Landscape Referral Response

Application Number:	DA2020/0593
Date:	27/07/2020
Responsible Officer:	Nick England
Land to be developed (Address):	Lot 3 DP 1245406 , 57 Mona Vale Road MONA VALE NSW 2103

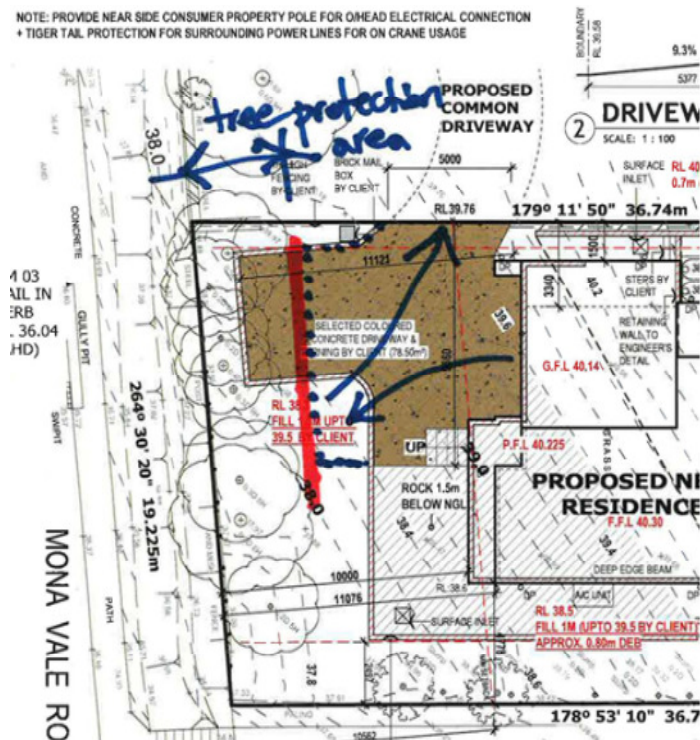
The development application includes a vehicular turning bay and associated walling and changes to existing ground level within the front setback that is likely to impact upon existing native vegetation. No arboricultural assessment is provided with the application to provide tree protection measures nor justify any removal of vegetation. The Site Plans show a retaining wall supporting the vehicular turning bay set at approximately 1.5m distance from the front boundary, whilst the Landscape Plan show this walling set at approximately 1.0m distance from the front boundary.

It is considered that an alternative vehicular swept path design layout is available to ensure the retention of the existing native vegetation located across the front boundary. The Statement of Environmental Effects and the Site Plans nominate these trees for retention, yet the Landscape Plans include notation for removal of existing Paperbark and Bottlebrush trees. No swept path analysis is included in the application.

NOTE: PROVIDE NEAR SIDE CONSUMER PROPERTY POLE FOR OHEAD ELECTRICAL CONNECTION
+ TIGER TAIL PROTECTION FOR SURROUNDING POWER LINES FOR ON CRANE USAGE

The development application provides insufficient and conflicting information to continue the landscape assessment. Applicants shall provide all necessary reports to assess the development application including accurate co-ordinated plans, and justification for any removal of trees and vegetation, and tree protection measures to be installed to ensure retention of existing trees and vegetation such as fencing, ground protection and/or trunk protection.

The SoEE notes that all existing trees which are native vegetation are proposed to be retained. The existing vegetation along the frontage within the site provides a screening that is worthy of retention to additionally satisfy clause C1.1 Landscaping of the Pittwater 21 DCP. Concern is raised that the landscape outcome as shown on the plans results in an elevated turning bay area above existing ground levels, that without adequate retention of vegetation and new screening plants will provide a dominate built form to the streetscape.
